ADDENDUM #01
DATE: 07/08/2025

Critical Care Addition
Paralleling Switchgear Replacement

PROJECT NUMBER: CP252281

E1.01

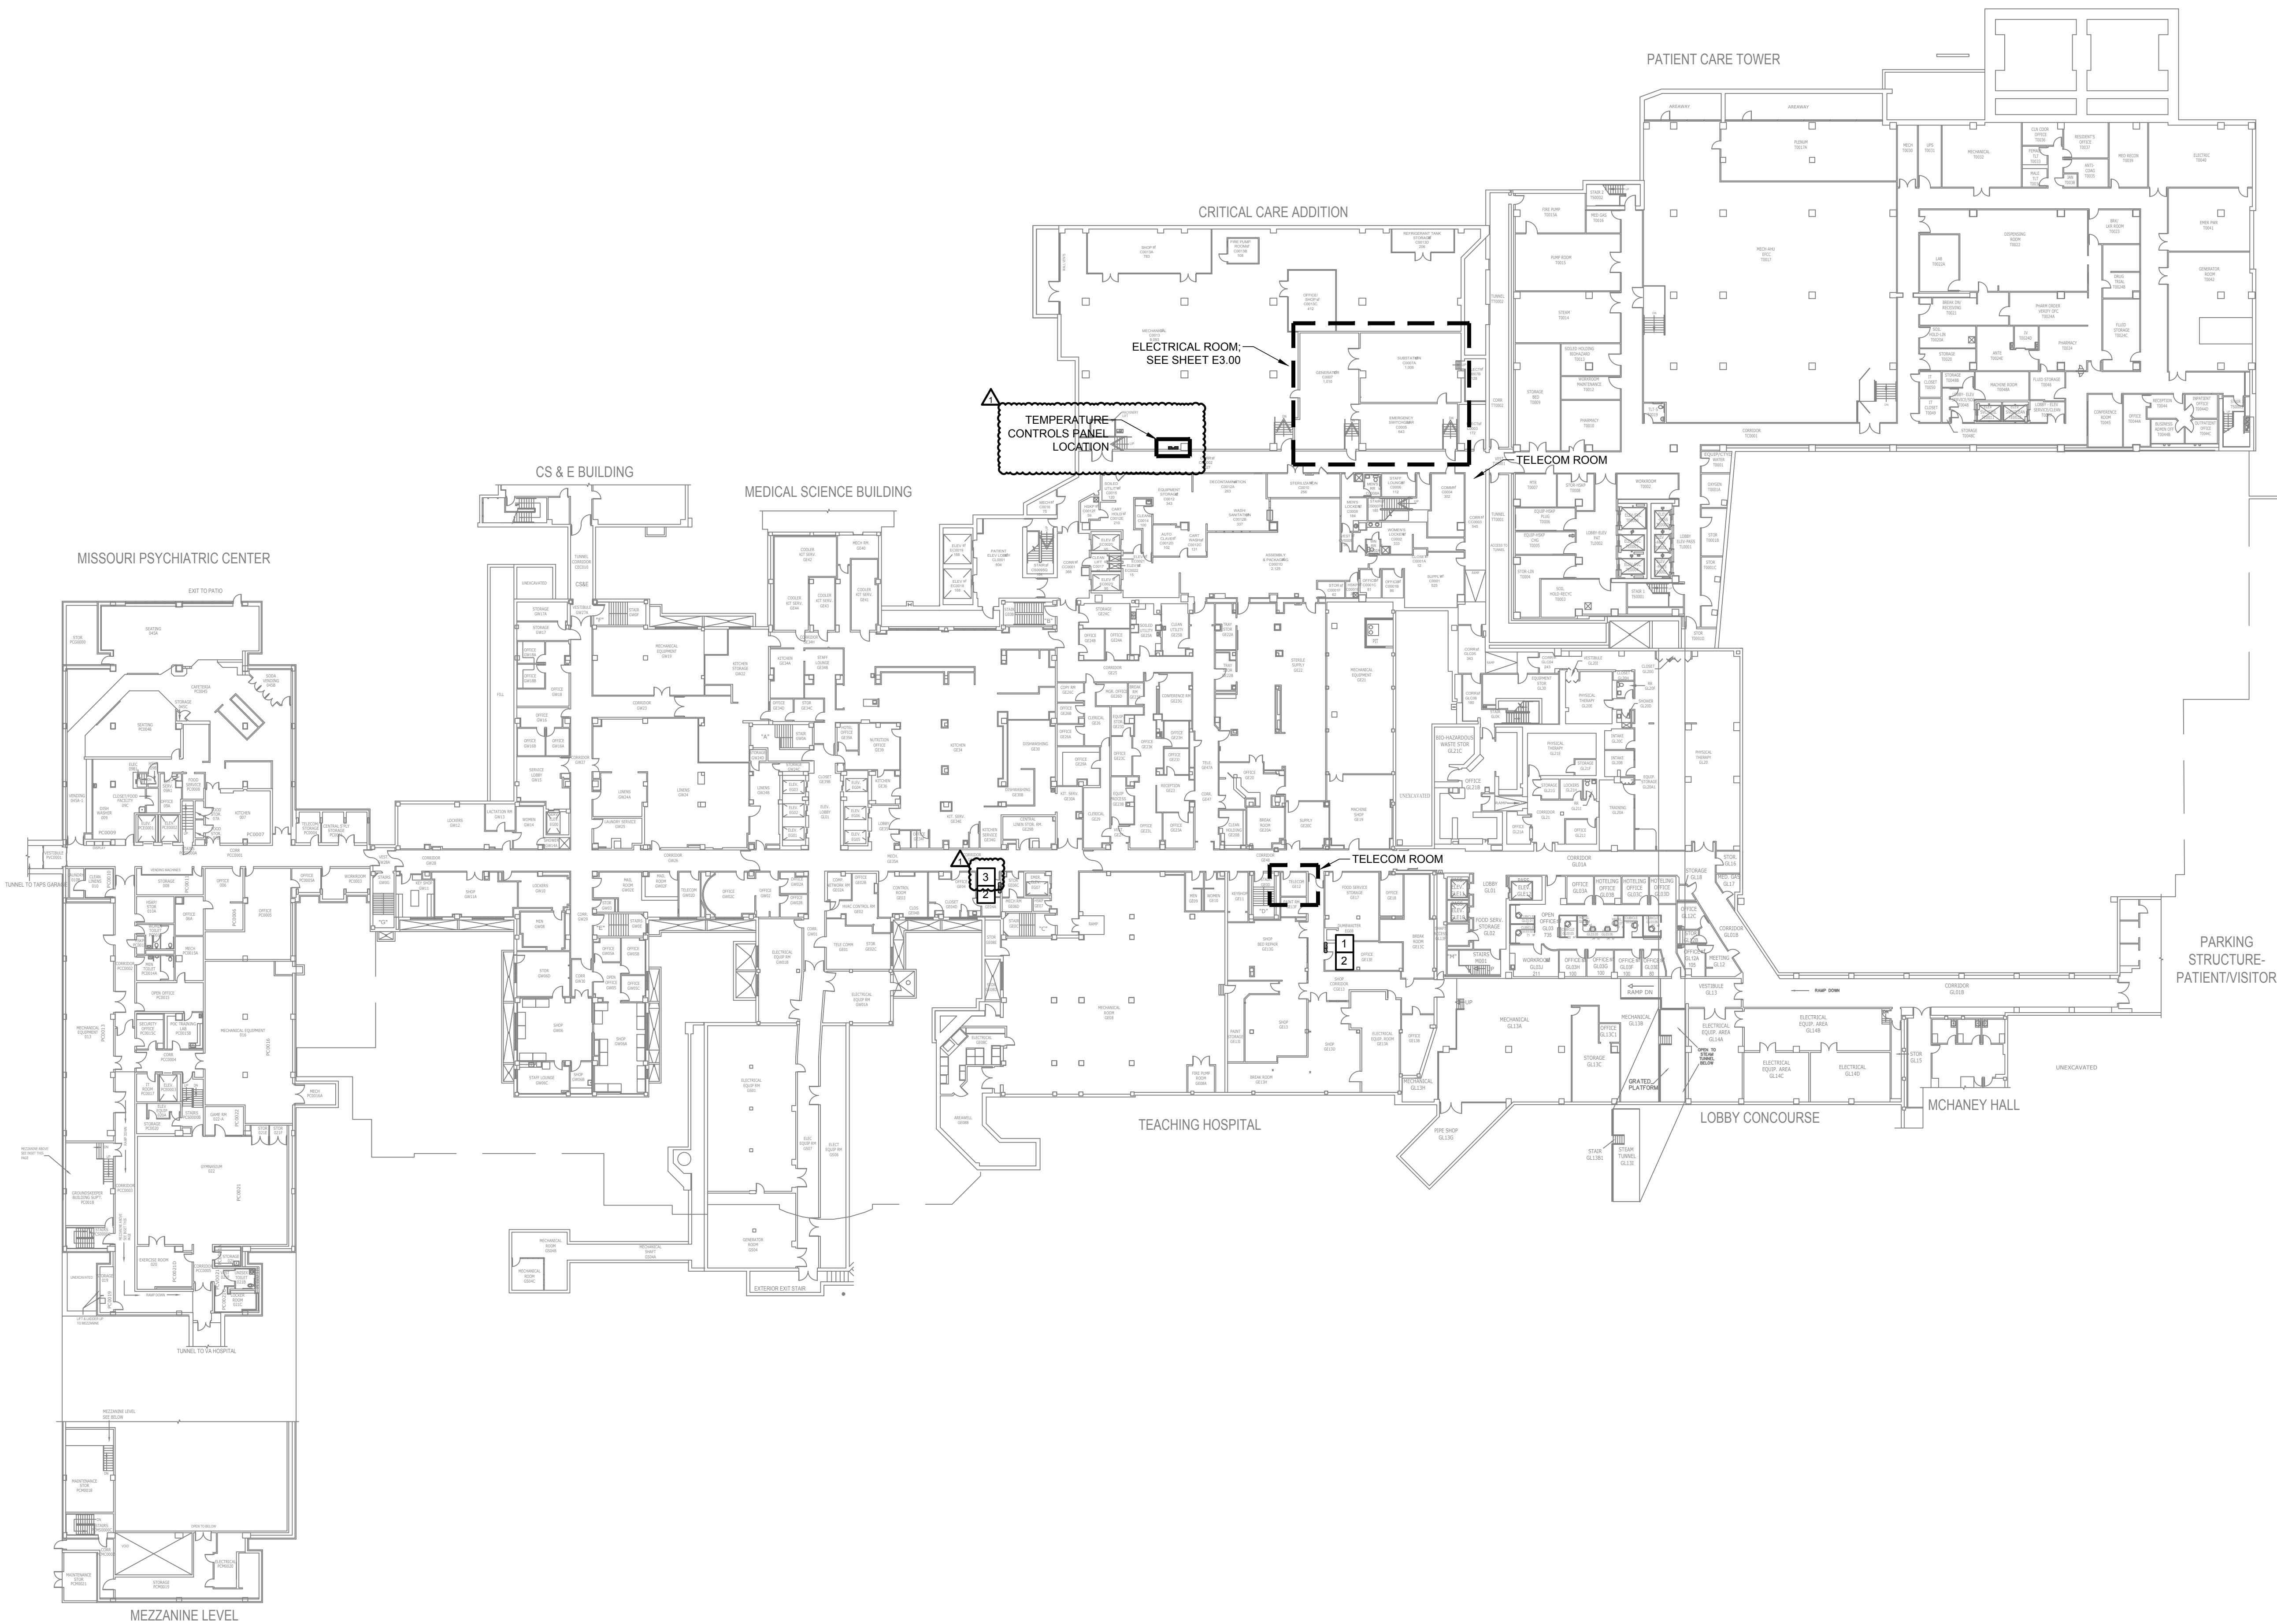
1. Sheet E1.01 – Overall Ground Floor Plan
 - a. ADDED Temperature controls panel location where JCI points shall be connect.
 - b. ADDED Keyed note 3 to clarify new versus existing annunciators.
 - c. CHANGED Keyed note 1 to 3 for the west annunciator panel.
